AMENDMENTS TO THE DRAWINGS

REMARKS

U.S. Patent App. Entitled: "Programming of Multi-Level Memory Cells on a Continuous Word Line";
Inventor: Sau Ching Wong; Attorney Docket No.: MLM006US1P

ANNOTATED SHEET

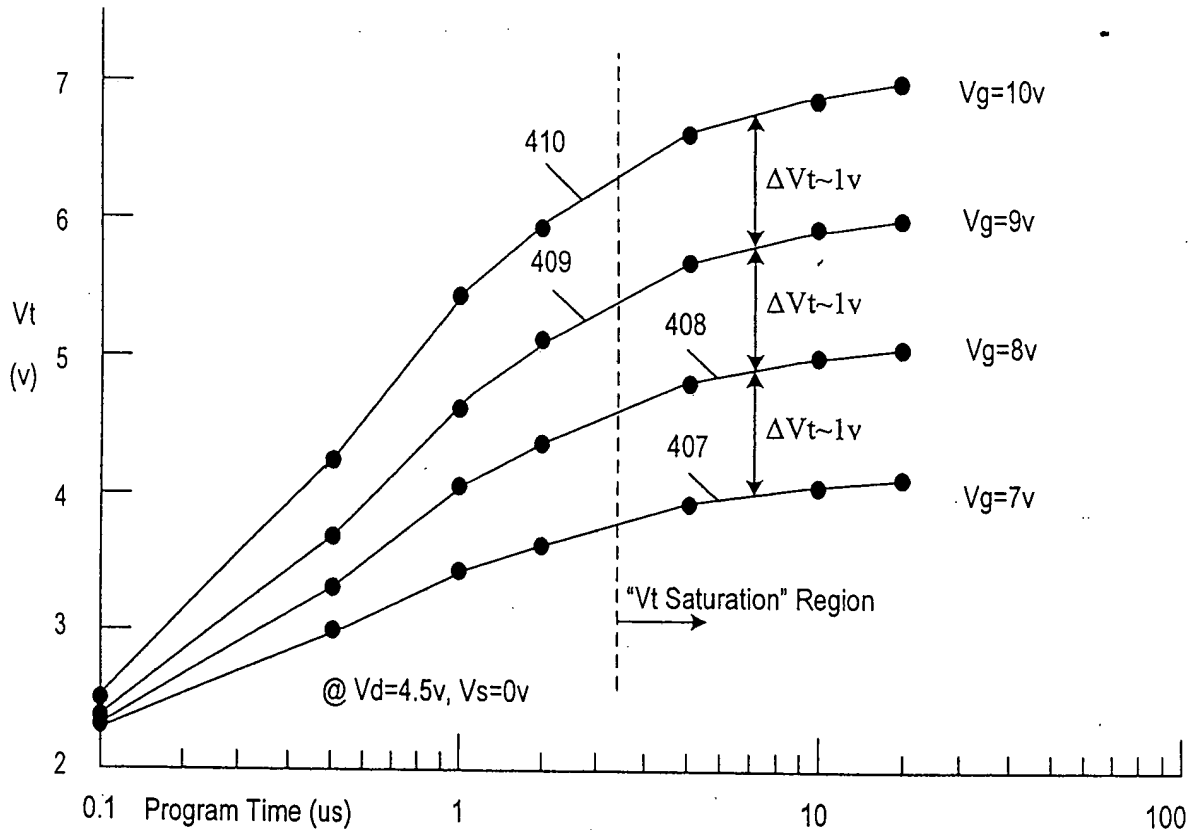
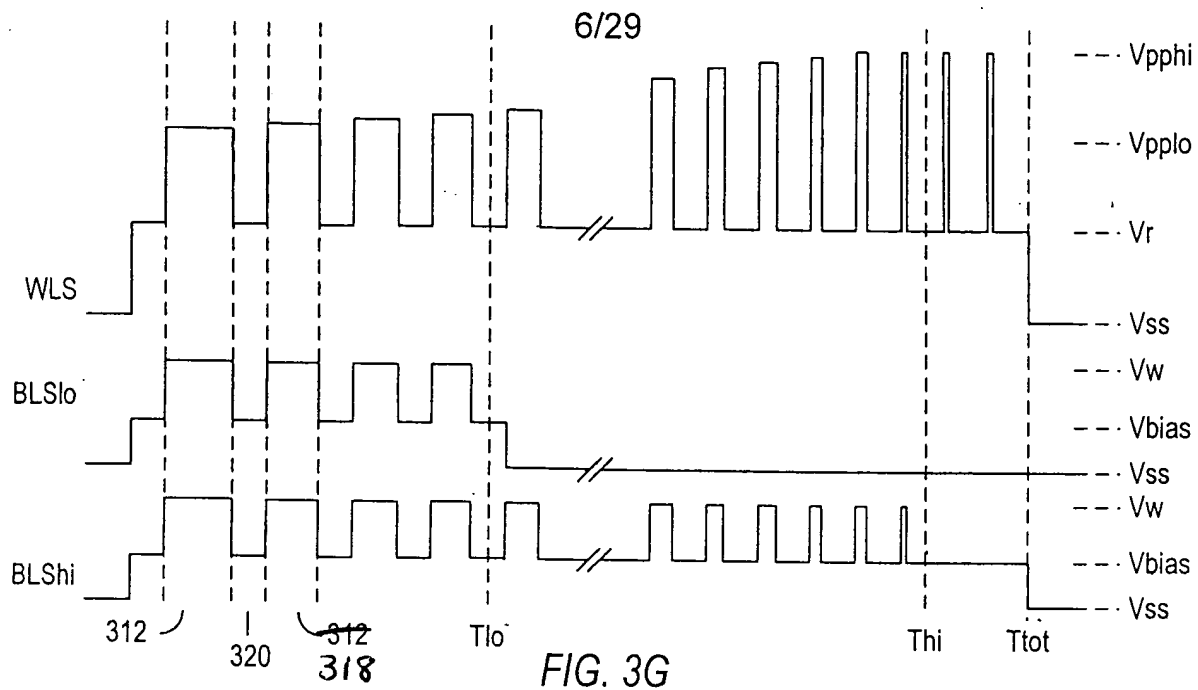
The attached sheets of drawings include changes to FIGs. 3G, 12A and 13. These sheets, which include FIG. 4, replace the original sheets including FIGs. 3G, 12A and 13. In FIG. 3G, reference number 318 replaces reference number 312. In FIG. 12A, reference number 115 replaces reference number 1210. In FIG. 13, reference numeral 1300 is added.

In regard to the first basis of objection, Applicant hereby amends FIG. 12A to replace reference numeral 1210 with reference numeral 150.

In regard to the second basis of objection, Applicant hereby amends: FIG. 3G to replace reference numeral 312 with reference numeral 318; FIG. 13 to show reference character 1300; and paragraph [0100] to replace "1040" with "1060."
